BELMONT BRIDGE REPLACEMENT PROJECT STATUS REPORT

OCTOBER 2018

Horizontal Wall

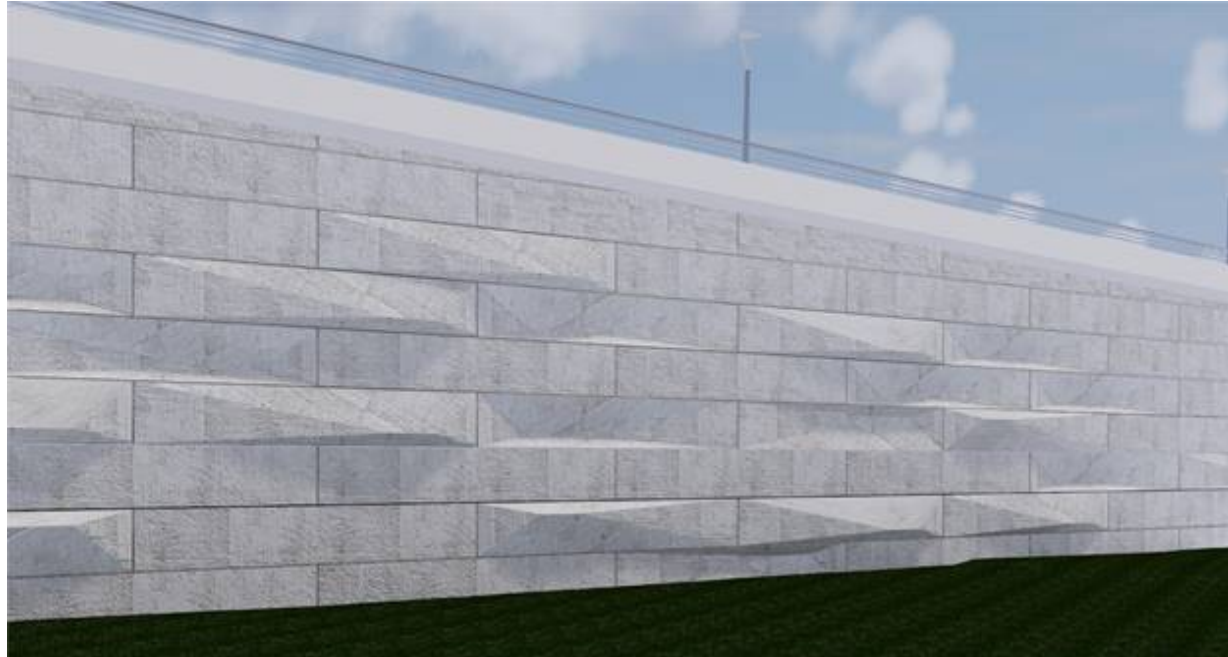
- Approve the horizontal concept of the MSE panels [aesthetic treatment of retaining walls/bridge abutments]; BAR requests further development of this design, which must come back to the BAR for approval
- Denial of the use of brick on the east side of the bridge [on abutment, north of Water Street, facing LexisNexis]
- Request to see an existing example of the proposed street light
- Request that applicant revisit details on the stairs—the south stairs particularly (between pedestrian plaza & pedestrian underpass to 9th/Avon Street) -- to create more fluidity and cohesion with the rest of the design concept for the bridge.

with the public with one exception: wall treatment was previously shown as vertical and is now being proposed as horizontal to 1) better hide joints, 2) simplify construction and 3) better contain or lower public expense. A sample of the pedestrian light fixture is being obtained for BAR review. And the design of the stairs to be constructed with the project will be advanced to determine more details and explore possible adjustments to obtain BAR's design directive. Once a future meeting date is scheduled with BAR, the date will be advertised to the public.
